VIRGINIA ELECTRIC AND POWER COMPANY
RICHMOND, VIRGINIA 23261

Serial No. 09-581
NL&OS/GDM R0
Docket Nos. 50-280/281
License Nos. DPR-32/37

VIRGINIA ELECTRIC AND POWER COMPANY
SURRY POWER STATION UNITS 1 AND 2
PROPOSED LICENSE AMENDMENT REQUEST
RELOCATION OF CORE OPERATING LIMITS TO THE CORE OPERATING LIMITS
REPORT (COLR) AND ADDITION OF COLR REFERENCES

TS FIGURE 2.1-1

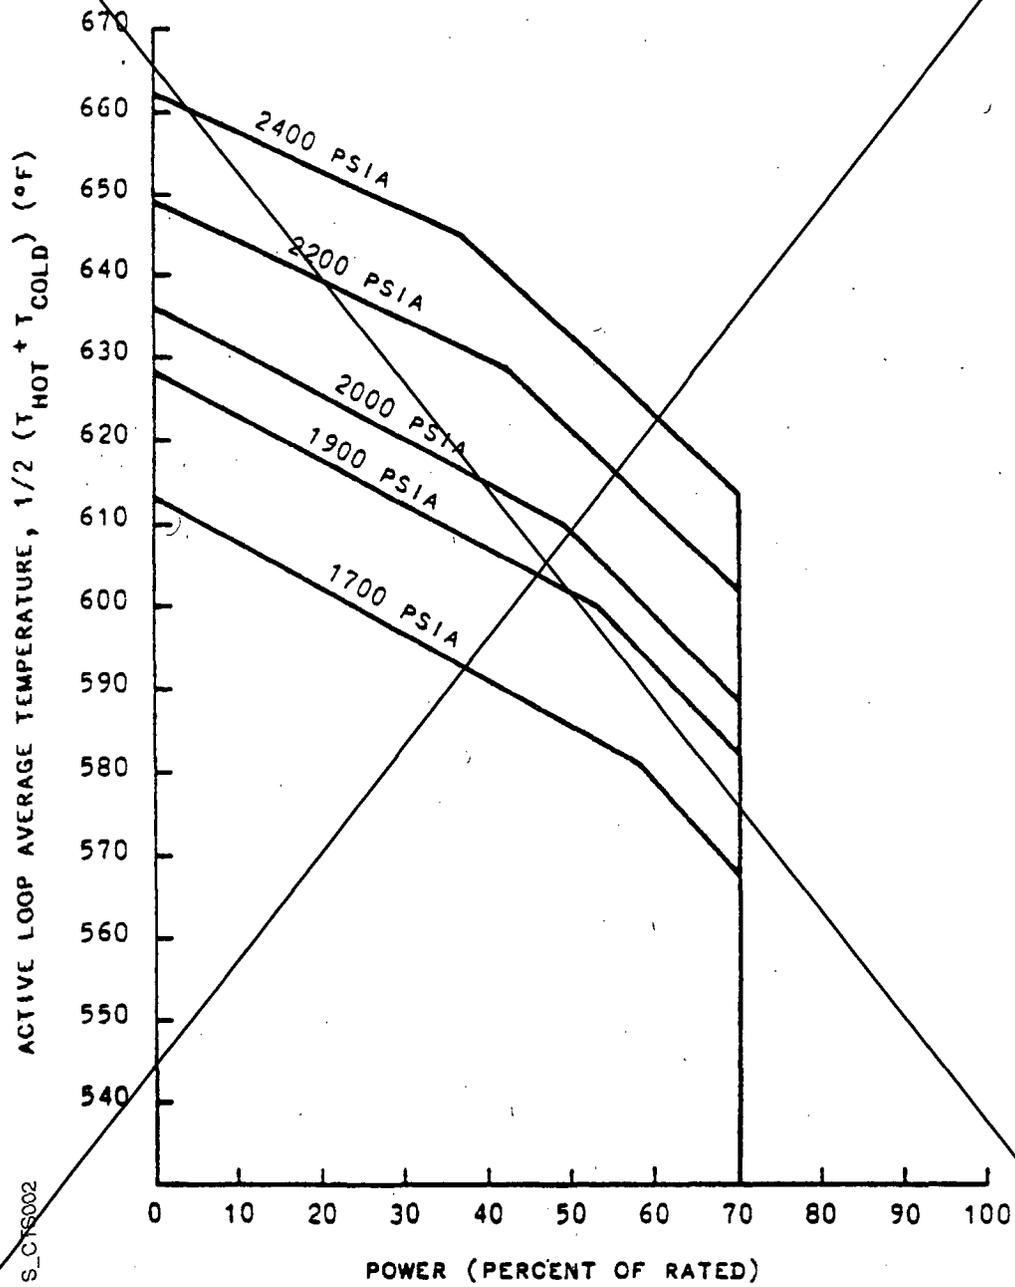
- Revise TS 2.1.B to refer to the CORE OPERATING LIMITS REPORT instead of TS Figures 2.1-1, 2.1-2 or 2.1-3.
 - Delete TS Figure 2.1-1 since this change relocates TS Figure 2.1-1 to the CORE OPERATING LIMITS REPORT.

The proposed changes to TS 2.1, "Safety Limit, Reactor Core," will relocate the Reactor Core Safety Limits figure (TS Figure 2.1-1) to the COLR, add new Safety Limits for departure from nucleate boiling ratio (DNBR) and peak fuel centerline temperature (TS 2.1.A.1.a and TS 2.1.A.1.b, respectively), and delete obsolete limits associated with N-1 Loop operation, since two-loop operation is prohibited for Surry (TS 2.1.A.2, TS 2.1.A.3, TS Figure 2.1-2, TS Figure 2.1-3) and fuel densification (TS Figure 2.1-4).

The guidance from TSTF 339-A Rev. 2 and WCAP-14483-A (Reference 3) has been used to relocate the Reactor Core Safety Limits in TS 2.1.A.1 from the TS to the COLR. The proposed change adds TS 2.1.A.1.a and TS 2.1.A.1.b that state the requirements that must be met to ensure that the Safety Limits will not be exceeded. The wording for TS 2.1.A.1.a has been modified from that provided in TSTF 339-A Rev. 2, WCAP-14483-A, and NUREG-1431 Rev. 3. The justification for deviating from the wording in the TSTF is to identify the statistical DNBR limit for the WRB-1 correlation, and the deterministic DNBR limits for the W-3 and WRB-1 DNB correlations. This deviation was previously approved by the NRC for Callaway (References 21 and 22). TS Figure 2.1-1 is being deleted from the TS since it is being relocated to the COLR.

In addition, TS 2.1.A.1 will be revised to read: "Exceed the limits specified in the CORE OPERATING LIMITS REPORT when full flow from three reactor coolant pumps exist, and the following Safety Limits shall not be exceeded:

~~FIGURE 2.1-2 REACTOR CORE THERMAL AND HYDRAULIC SAFETY LIMITS, TWO LOOP OPERATION, LOOP STOP VALVES OPEN~~

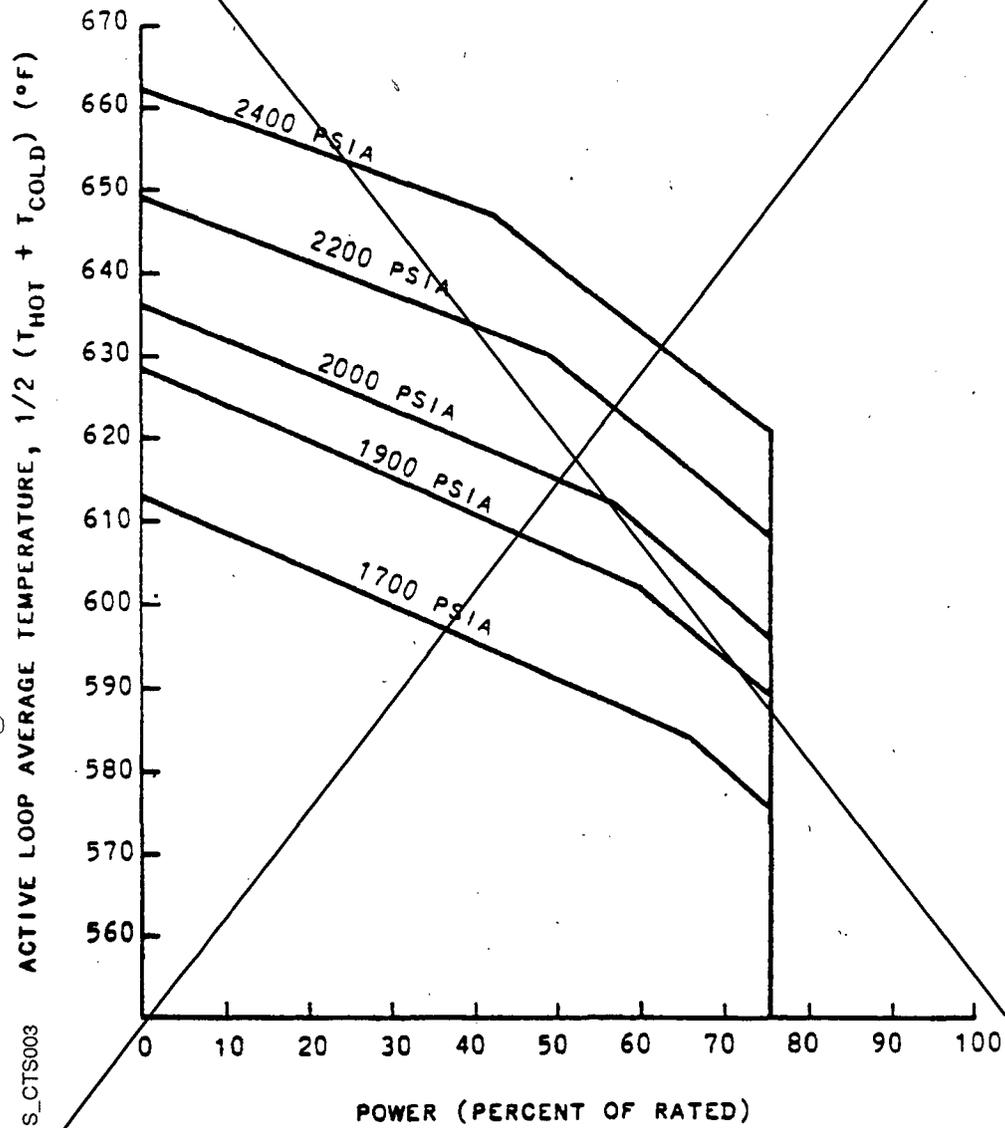
- Delete obsolete TS 2.1.A.2 and TS 2.1.A.3, and TS Figures 2.1-2, 2.1-3, and 2.1-4.
 - Revise TS 2.1 Basis to reflect TS changes and delete obsolete information.

This change request also proposes to delete TS 2.1.A.2 and TS 2.1.A.3, as well as TS Figures 2.1-2 and 2.1-3 that are referenced by the TS. TS 2.1.A.2 and TS 2.1.A.3 support two-loop operation at Surry Power Station which is not allowed by TS 3.1.A.1.a, which requires that three reactor coolant pumps be in operation in non-isolated loops whenever the reactor is critical. TS 2.1.A.2 and TS 2.1.A.3 and the referenced figures are obsolete and can therefore be deleted.

Deletion of the obsolete limits associated with N-1 loop operation (TS 2.1.A.2, TS 2.1.A.3, TS Figure 2.1-2, TS Figure 2.1-3) and fuel densification (TS Figure 2.1-4) is acceptable since these limits no longer represent limiting conditions for operation and are not required to be in the TS.

Figure 2.3-1 OPAT and OIAT $f(\Delta I)$ Function

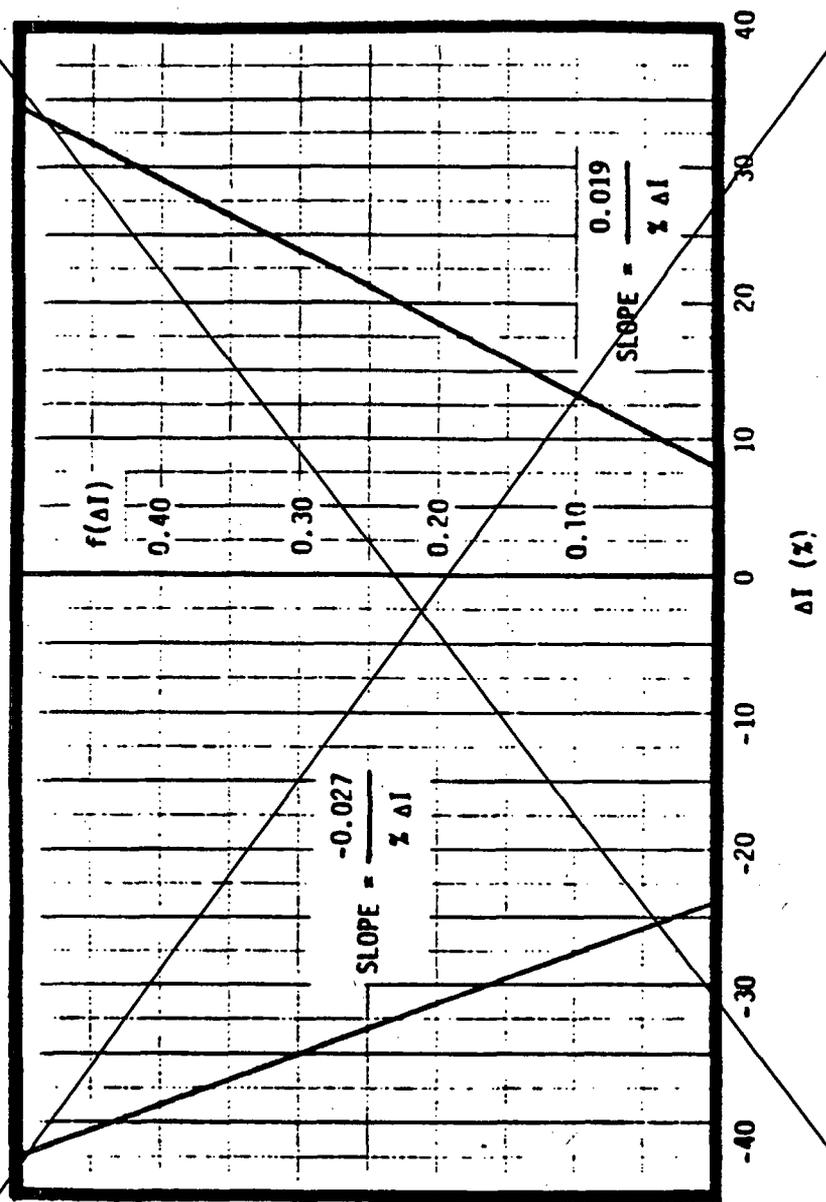
- Delete TS Figure 2.3-1.
 - Revise TS 2.3 Basis to reflect TS changes.

The proposed change will also delete TS Figure 2.3-1, "OP ΔT and OT ΔT $f(\Delta I)$ Function". The current TS states, " $f(\Delta I) =$ function of ΔI , percent of rated core power as shown in TS Figure 2.3-1" for the Overtemperature ΔT function and " $f(\Delta I)$ as defined in (d) above" for the Overpower ΔT function. The $f(\Delta I)$ specification for the Overtemperature ΔT function will now be provided as algebraic formulas in TS 2.3.A.2.d with the cycle-specific limits values denoted with (*) to be specified in the CORE OPERATING LIMITS REPORT. The $f(\Delta I)$ specification for the Overpower ΔT function remains unchanged. Thus, the information in the figure is redundant and will be deleted.
